## Fore Peak Ballast Systems and Fore Peak Space Arrangements of Tankers

ID: DX24-19

**Amended-Original Requirements Comparison Table**  
**(Fore Peak Ballast Systems and Fore Peak Space Arrangements of Tankers)**

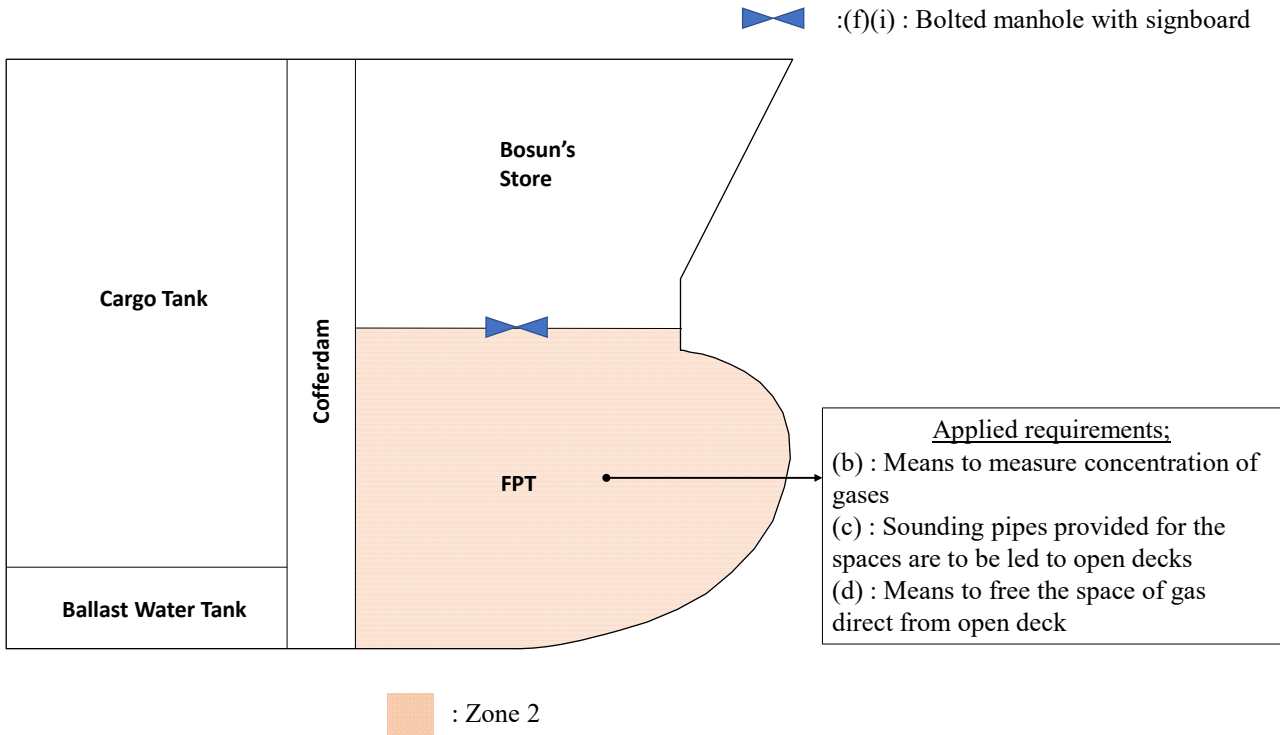
Amended	Original	Remarks
<p>(3) In cases where ballast pipes of forward ballast tanks are led to other ballast piping systems serving ballast tanks which are adjacent to cargo oil tanks, the following requirements are to be complied with <u>(samples of the arrangements and the applicable provisions to forward ballast tanks and enclosed spaces are shown in Fig. D14.3.2)</u>:</p> <p>(a) In applying the requirements specified in <b>Part H of the Rules</b>, forward ballast tanks are to be considered to be hazardous areas <u>in either of the following (i) or (ii) cases</u>:</p> <p>(i) <u>In cases where forward ballast tanks are adjacent to cargo oil tanks, said tanks are considered to be Zone 1 as specified in 4.3.1(2)(c), Part H of the Rules. Air pipe openings provided for forward ballast tanks are to be located on open decks at an appropriate distance of not less than 3 m away from any sources of ignition. In addition, the area around such air pipe openings is defined as a hazardous area in accordance with 4.3.1(2)(i), Part H of the Rules and 4.3.1(3)(a), Part H of the Rules. This, however, does not apply to the sounding pipe openings and manholes of forward ballast tanks.</u></p> <p>(ii) <u>In cases where forward ballast tanks are separated from the cargo oil tanks by cofferdams, said tanks are considered to be Zone 2 as specified in 4.3.1(3)(h), Part H of the Rules. In such cases, air pipe openings provided for forward ballast tanks are to be located on open decks.</u></p>	<p>(3) In cases where ballast pipes of forward ballast tanks are led to other ballast piping systems serving ballast tanks which are adjacent to cargo oil tanks, the following requirements are to be complied with:</p> <p>(a) In applying the requirements specified in <b>Part H of the Rules</b>, forward ballast tanks are to be considered to be hazardous areas as specified in <b>4.3.1(2)(c), Part H of the Rules</b>.</p> <p>(b) <u>Vent pipe openings provided for forward ballast tanks are to be located on open decks at an appropriate distance of not less than 3 m away from any sources of ignition. In addition, the area around such vent pipe openings is defined as a hazardous area in accordance with 4.3.1(2)(i), Part H of the Rules and 4.3.1(3)(a), Part H of the Rules.</u></p> <p>(Newly added)</p>	<p>IACS UR F44 Rev.3 para.1.1a), f)</p>

Amended	Original	Remarks
<p><u>(b)</u> Means are to be provided, on open decks, to allow measurement of the concentration of <u>toxic and flammable</u> gases within forward ballast tanks. In this case, such means may be a combination of <u>sampling pipes and portable detecting instruments specified in 4.5.7(2)(a), Part R of the Rules or 13.2.1, Part S of the Rules</u>. Such sampling pipes may be those sounding pipes specified in the following <u>(c)</u>.</p> <p><u>(c)</u> Sounding pipes provided for forward ballast tanks are to be led to open decks.</p> <p><u>(d)</u> <u>Means to free forward ballast tanks of gas direct from open decks are to be provided.</u></p> <p><u>(e)</u> Access into forward ballast tanks is to be direct from open decks.</p> <p><u>(f)</u> <u>Notwithstanding (e) above, indirect access from open decks into the forward ballast tanks through enclosed spaces such as cofferdams (hereinafter referred to as “entry spaces”)</u> may be acceptable provided that the following <u>(i) to (iii)</u> are satisfied.</p> <p><u>(i)</u> Access into forward ballast tanks <u>is</u> to be a gas tight bolted manhole. In this case, a warning sign is to be provided at the manhole stating that the forward ballast tank may only be opened after it has been proven to be <u>toxic and flammable gas</u> free or the electrical equipment which is not electrically safe in <u>the forward ballast tank</u> is isolated.</p> <p><u>(ii)</u> <u>In cases where entry spaces are accessed</u></p>	<p><u>(c)</u> Means are to be provided, on open decks, to allow measurement of the concentration of flammable gases within forward ballast tanks. In this case, such means may be a combination of <u>portable detecting instruments and sampling pipes</u>. Such sampling pipes may be those sounding pipes specified in the following <u>(d)</u> in cases where <u>deemed appropriate by the Society</u>.</p> <p><u>(d)</u> Sounding pipes provided for forward ballast tanks are to be led to open decks.</p> <p>(Newly added)</p> <p><u>(e)</u> Access into forward ballast tanks is to be direct from open deck. <u>However</u>, indirect access from open decks into the forward ballast tanks through enclosed spaces may be acceptable provided that the following <u>(i) or (ii)</u> is satisfied.</p> <p><u>(i)</u> <u>In cases where enclosed spaces are separated from the cargo oil tanks, access into forward ballast tanks are to be a gas tight bolted manhole located in such enclosed spaces</u>. In this case, a warning sign is to be provided at the manhole stating that the forward ballast tank may only be opened after it has been proven to be <u>gas</u> free or the electrical equipment which is not electrically safe in <u>the enclosed space</u> is isolated.</p> <p>(Newly added)</p>	<p>IACS UR F44 Rev.3 para.1.1g)</p> <p>IACS UR F44 Rev.3 para.1.1d)</p> <p>IACS UR F44 Rev.3 para.1.1e)</p> <p>IACS UR F44 Rev.3</p> <p>(e), (f): para.1.1b)</p> <p>(f)(i): para.1.1b)  (f)(ii): para.2.2a), b)  (f)(iii): para.2.1</p>

Amended	Original	Remarks
<p><u>through other enclosed spaces such as a bosun store, means to free the entry spaces of gas direct from open decks are to be provided. In addition, access into the entry spaces is to be a gas tight bolted manhole. In such cases, a warning sign is to be provided at the manhole stating that the entry space may only be opened after it has been proven to be toxic and flammable gas free, or any electrical equipment that is not electrically safe in the entry space is isolated.</u></p> <p><u>(iii) In cases where entry spaces have common boundaries with the cargo tanks, such entry spaces are to satisfy (a)(i), (b), (c) and (d) above in addition to the relevant requirements of hazardous areas.</u></p> <p><u>(g) In cases where a bow thruster space is provided, the ballast piping passing through the bow thruster room is to be fully welded (e.g. without any flange joints). In addition, the bulkhead valve specified in 13.2.5, Part D of the Rules is to be located at fore side of collision bulkhead within the forward ballast tank.</u></p>	<p><u>(ii) In cases where enclosed spaces have common boundaries with the cargo tanks, such enclosed spaces are to satisfy the relevant requirements of hazardous areas and are, in addition, to be well ventilated.</u></p> <p>(Newly added)</p>	<p>IACS UR F44 Rev.3 para.1.1f)</p>

Amended	Original	Remarks
<p><u>Fig. D14.3.2</u> (Sample 1) Applicable to both oil tankers and chemical tankers</p> <p>The diagram illustrates the fore peak space arrangements for oil tankers and chemical tankers. It shows a cross-section of the ship's hull with the following components and requirements:</p> <ul style="list-style-type: none"> <li><b>Cargo Tank</b>: The main storage tank for cargo.</li> <li><b>Ballast Water Tank</b>: The tank for ballast water.</li> <li><b>Void Tank</b>: A tank used for gas collection, with a requirement for a bolted manhole with a signboard.</li> <li><b>FPT (Fore Peak Tank)</b>: A tank used for gas collection, with requirements for measuring gas concentration, sounding pipes, and gas freeing.</li> <li><b>Bosun's Store</b>: A storage area for tools and equipment.</li> <li><b>Cofferdam</b>: A space between the Cargo Tank and the Ballast Water Tank.</li> <li><b>Zone 2</b>: A designated area for gas collection.</li> </ul> <p><b>Applied requirements:</b></p> <ul style="list-style-type: none"> <li>(f)(i) and (ii) : Bolted manhole with signboard</li> <li>(f)(ii) : Means to free the space of gas direct from open deck</li> <li>(b) : Means to measure concentration of gases</li> <li>(c) : Sounding pipes provided for the spaces are to be led to open decks</li> <li>(d) : Means to free the space of gas direct from open deck</li> </ul>		<p>IACS UR F44 Rev.3 samples 1, 2, 5, 6 samples 3, 4</p>

Amended		Original	Remarks
<div>Fig. S1.3.1-3</div> <div><div><div>(Sample 1) Applicable</div></div><div><div>(Sample 2) Applicable</div></div></div> <div><div><div>(Sample 3) Applicable</div></div><div><div>(Sample 4) Applicable</div></div></div>			IACS UI SC211 Rev.1 Figure 2

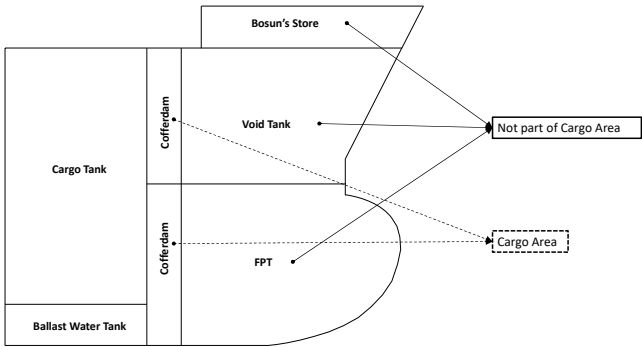
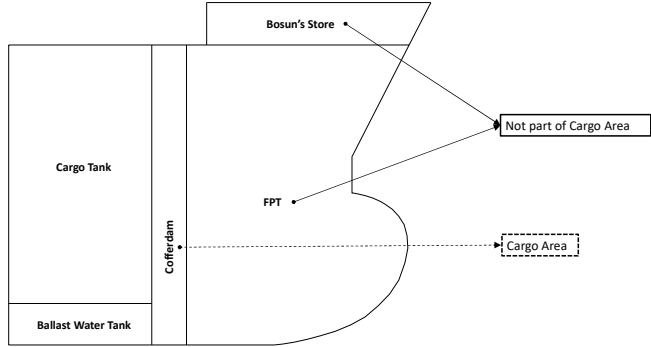
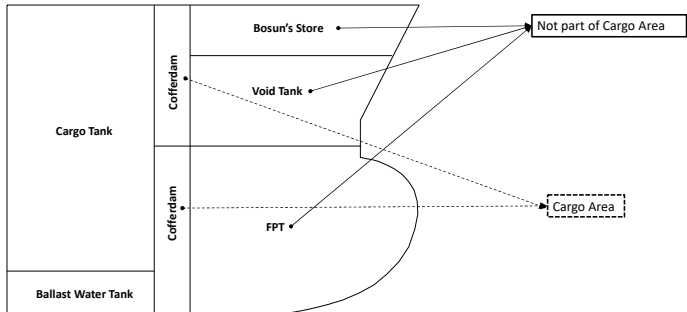
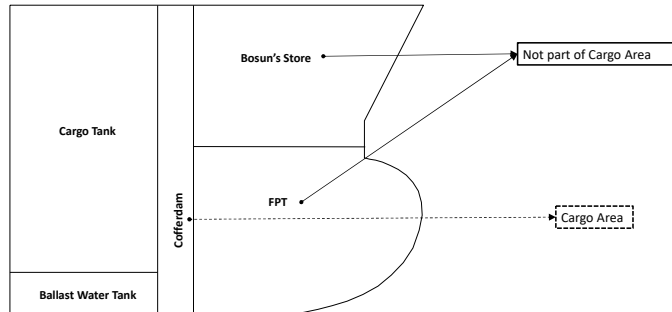
Amended	Original	Remarks
<p align="center"><b>GUIDANCE FOR THE SURVEY AND CONSTRUCTION OF STEEL SHIPS</b></p> <p align="center"><b>Part S SHIPS CARRYING DANGEROUS CHEMICALS IN BULK</b></p> <p align="center"><b>S1 GENERAL</b></p> <p><b>S1.3 Definitions</b></p> <p><b>S1.3.1 Definitions</b></p> <p>2 The term “cargo area” referred to 1.3.1(5), Part S of the Rules is to be as follows.</p> <p>(1) <u>The area excludes the fuel oil tanks adjacent to the cargo tanks or slop tanks of the arrangement as given in Fig. S1.3.1-1. However, the requirements specified in 3.4, Part S of the Rules apply.</u></p> <p>(2) <u>A non-hazardous area in the forecastle space which is protected from cargo tanks by cofferdams, etc. is not to be defined as part of the cargo area. However, compartments located above cofferdams, etc. protecting non-hazardous areas are to be defined as part of the cargo area (refer to Fig. S1.3.1-3).</u></p>	<p align="center"><b>GUIDANCE FOR THE SURVEY AND CONSTRUCTION OF STEEL SHIPS</b></p> <p align="center"><b>Part S SHIPS CARRYING DANGEROUS CHEMICALS IN BULK</b></p> <p align="center"><b>S1 GENERAL</b></p> <p><b>S1.3 Definitions</b></p> <p><b>S1.3.1 Definitions</b></p> <p>2 The term “cargo area” referred to 1.3.1(5), Part S of the Rules excludes the fuel oil tanks adjacent to the cargo tanks or slop tanks of the arrangement as given in Fig. S1.3.1-1. However, the requirements specified in 3.4, Part S of the Rules apply.</p> <p align="center">(Newly added)</p>	<p>IACS UI SC211 Rev.1 Interpretation 2</p>
